TOPSAIL

TOPSAIL REVISION LIST - STRUCTURAL:

TOPSAIL REVISION LIST - ARCHITECTURAL:

CHANGES ON 03-30-2020

SLAB INTERFACE

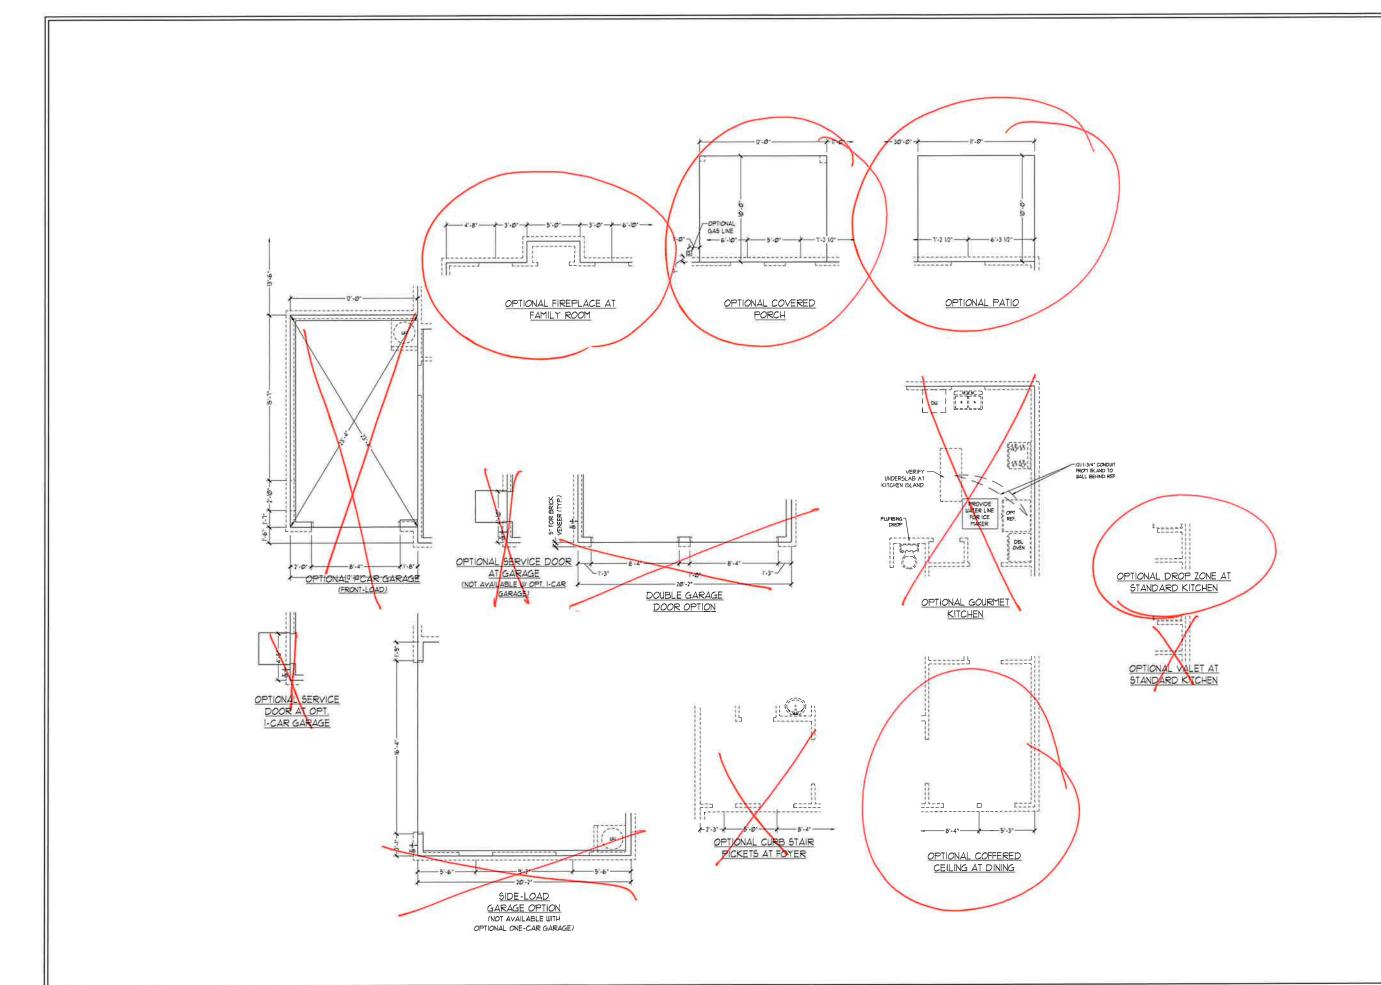
- 11.0 SEPARATED ALL OPTIONS FROM BASE PLAN TO CORRESPONDING SHEETS
- 12. ADDED DIAGONAL DIMENSION ON SLAB INTERFACE PLAN
- 13. ADDED PLUMBING DROPS TO SLAB INTERFACE PLAN

- 14. ADDED CONDUIT IN KITCHEN OF THE SLAB INTERFACE PLAN
- 15 CHANGED COLUMN ON PATIO TO 8"x8"
- 16. CHANGED EXTERIOR WALLS FROM 2x6 TO 2x4 EXCEPT AT SHADED AREAS
